Modification Application: PRS 22-0091

Request: Minor Modification to PD

The request is for a minor modification to a planned development (PD 05-0809). The purpose of the modification is to add an access point to the approved Planned Development. No additional changes to approved uses, densities, or other revisions are being requested.

2.4 Proposed Site Plan (partial provided below for size and orientation purposes. See Section 8.2 for full site plan)

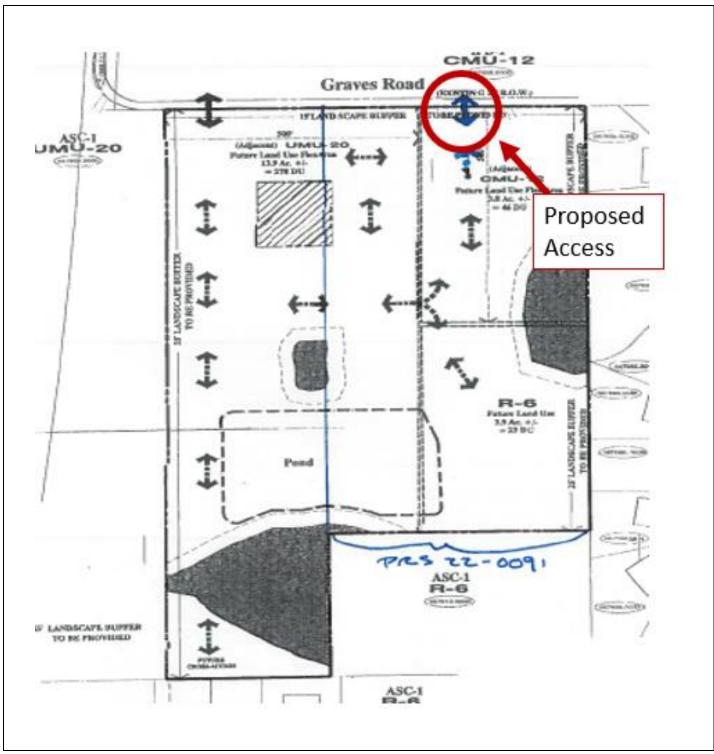
The applicant is seeking to modify existing Planned Development zoning (PD 05-0809) to add an access point to the currently approved Planned Development. The proposed modification consists of two folios (folio no. 67908.0000 and 67909.0000) within PD 05-0809.

Notes: Second access requested to Graves Rd. Existing condition of approval requires additional connectivity to south.

The existing PD site plan (CSP 05-0809) is approved for one site access connection to Graves Rd. A second site access connection is permissible per LDC, Sec. 6.04.03 I., a residential development may have a second access connection on a local road if the project's peak hour traffic exceeds 90 trips.

[Staff recommends deletion of this condition, as it was based upon Hillsborough County's former system for the evaluation and mitigation of transportation impacts, i.e. transportation concurrency. Given Florida House Bill 7202 (2011), §163.3180 (Florida Statutes), and Section 40-68, et seq. (Hillsborough County Code of Ordinances), this condition is no longer enforceable. Final evaluation of turn lane warrants will be done in accordance with Section 6.04.04.D. at the time of plat/site/construction plan review.]
